1. **Kincaid Mixed Use (Red Apple site)**
City block of Maple, Kincaid, Alder and Academy
PLN-2021-0025
Design Review for the construction of a 3-4 story mixed use building in the TCP. Projects will include structured parking, open space landscaping and frontage improvements.
2. **7-11**
15006 Main Street E (Corner of Main and Valley)
PLN-2020-0078
Design Review for 7-11 convenience store and fuel station. Project will include landscaping, parking and pedestrian areas.

REPORT TO THE DESIGN COMMISSION
from the DEVELOPMENT SERVICES DEPARTMENT

Permit Number: PLN-2021-0025

Project Components: Design Review for the development of a 3 and 4 story mixed use building with structured parking, landscaping, storm water and outdoor seating and frontage improvements.

Shading Study		Spring/Fall Equinox (March/September 21)	Exhibit A
10 AM			
12 PM			
2 PM

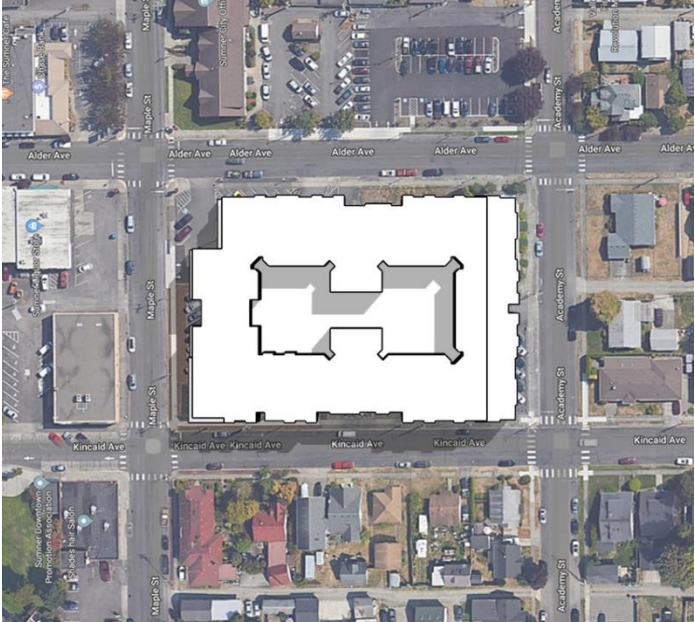
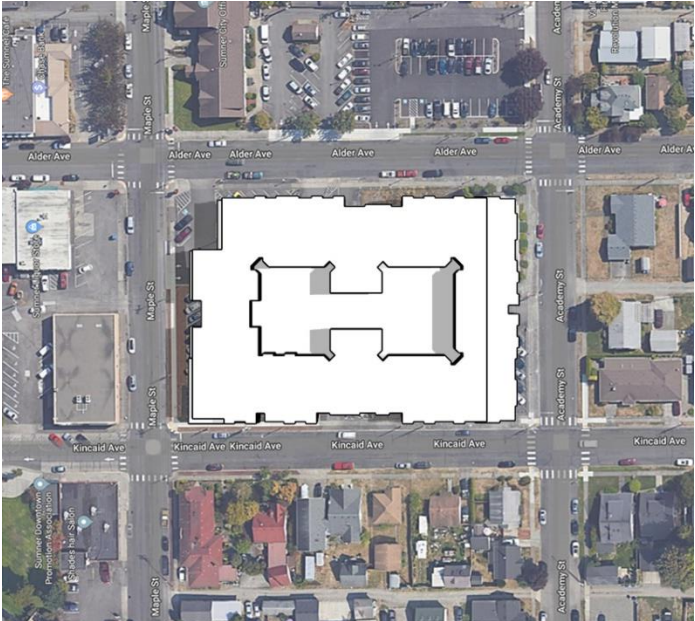
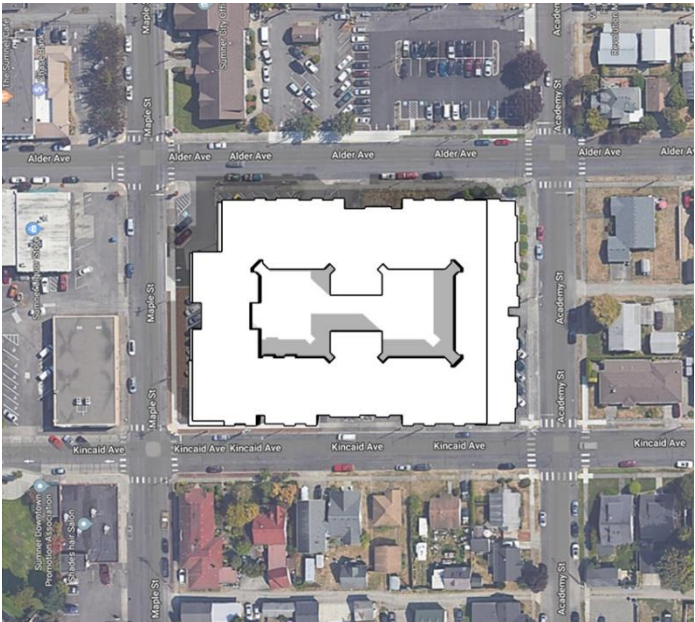
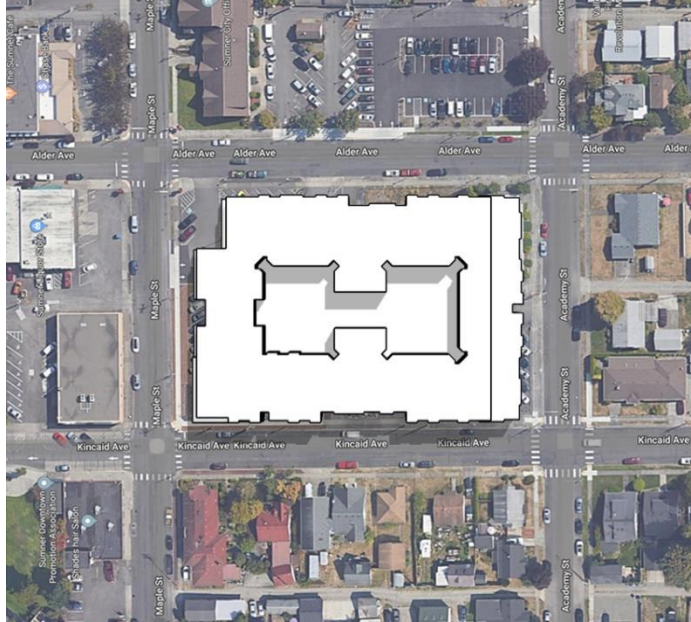
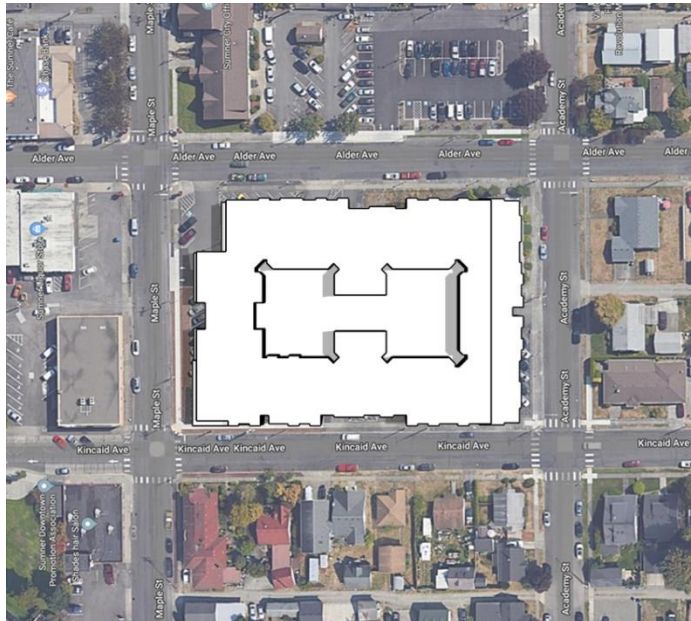
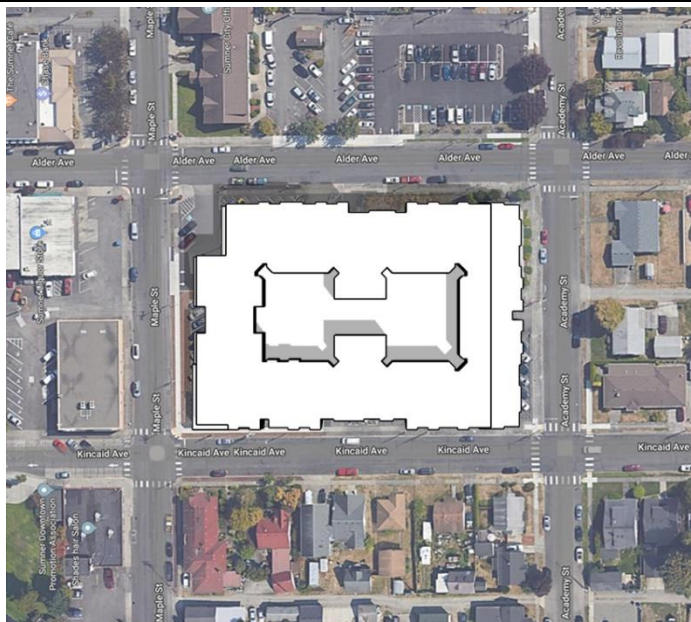
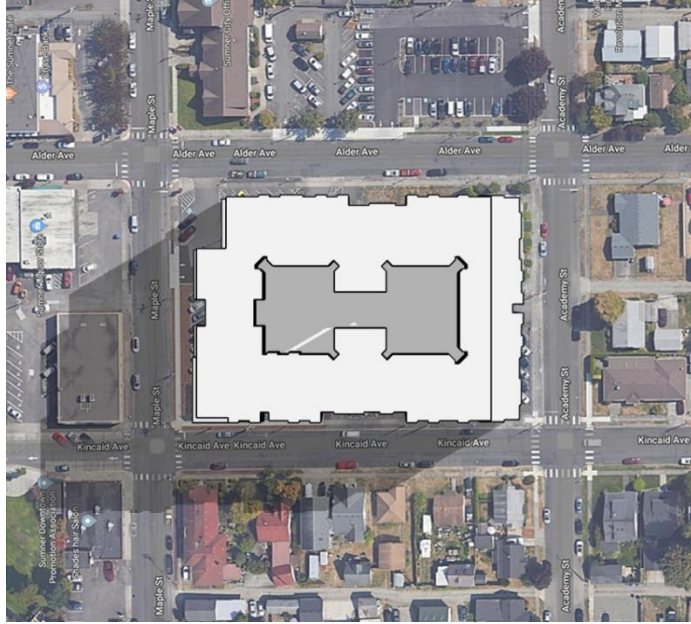
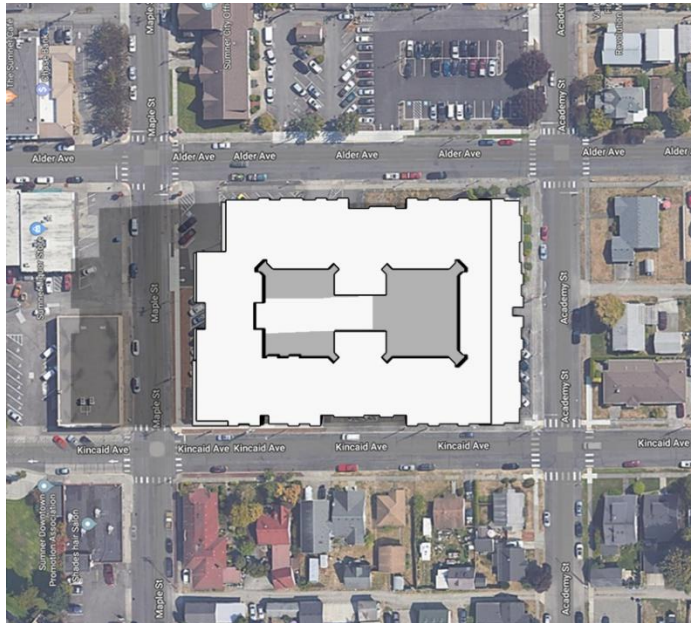
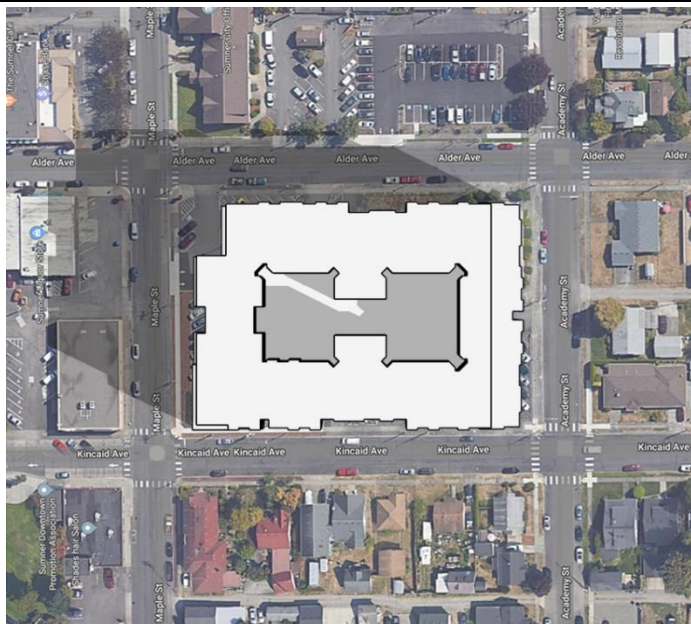
- ii) Provide pedestrian-oriented facades on some or all buildings facing the space.**
 - iii) Consideration of the sun angle at noon and the wind pattern in the design of the space.**
